Formal Interpretations/ Interprétation formelle

This section lists questions that individuals have submitted about a particular standard. Each question has been reviewed and answered by the appropriate committee. If you would like to submit a question about a particular standard, please see the end notes in the preface of that standard.

Figure 11 (d) – test specimen mounting arrangement for TDD's.

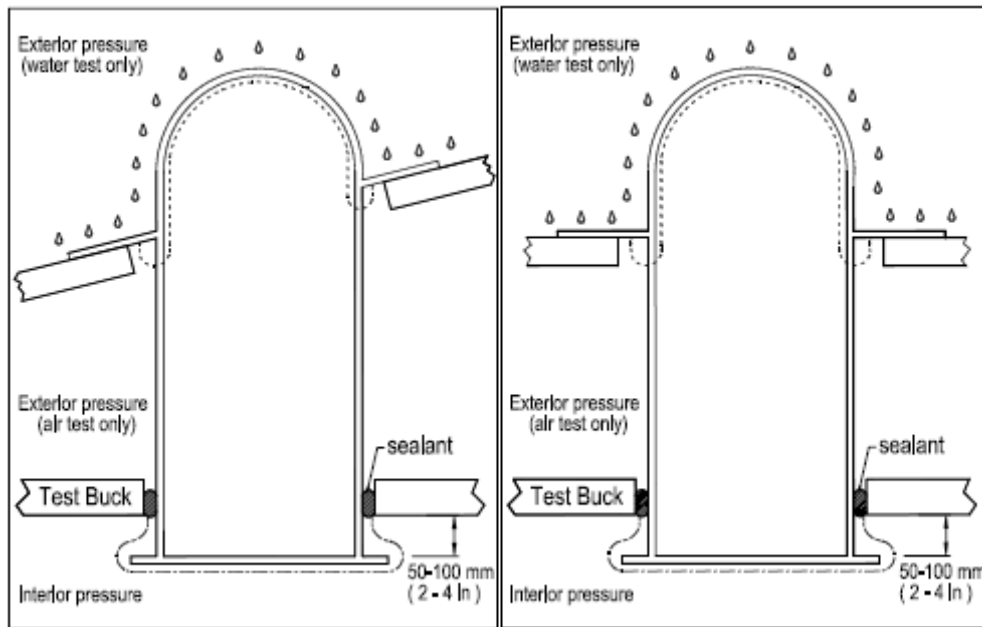
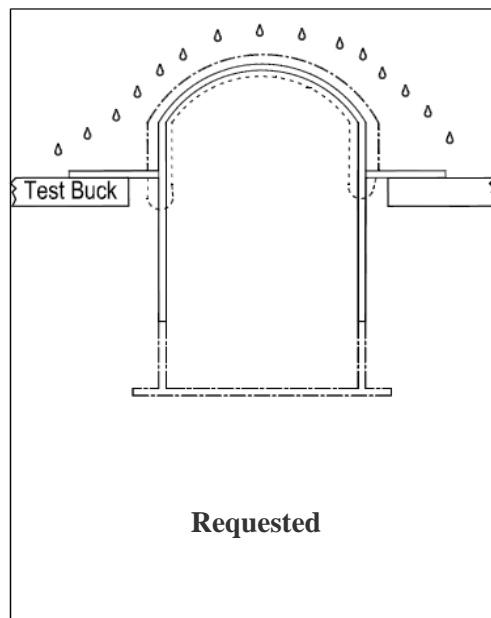
In this figure, there is a seal shown between a horizontal test buck at "ceiling" level and the outside of the light transmitting tube. In the air leakage testing mode described for this arrangement, it is apparent that the intent is to treat the "attic space" thus formed as unconditioned space with insulation at the ceiling so that all leakage to/from this unconditioned space and the outside space that enters the tube can be measured at the tube exit point (diffuser) in the "conditioned" space below the ceiling.

Some TDD manufacturers offer variants that are designed to be used only in commercial construction, where the tube is to be installed in conditioned space (insulation at the roof). NFRC procedures have been updated to cover this product variant, where they chose the term “Hybrid”

TDD, abbreviated as “HTDD”. The next revision of NAFS standard/specification will need to address this product variant because the current air leakage test procedure shown in Figure 11(d) is inappropriate when the product is not used with an insulated ceiling. This TI is to bridge the time gap until that revision is published in 2011.

Question: Shall it be permitted to treat a product designed and specified by the manufacturer to be used only where the tube will be installed in conditioned space, and is a minimum of 20” across, as a "Tubular Skylight", and test it according to the skylight testing provisions for air, water and structural performance?

Answer: Yes.
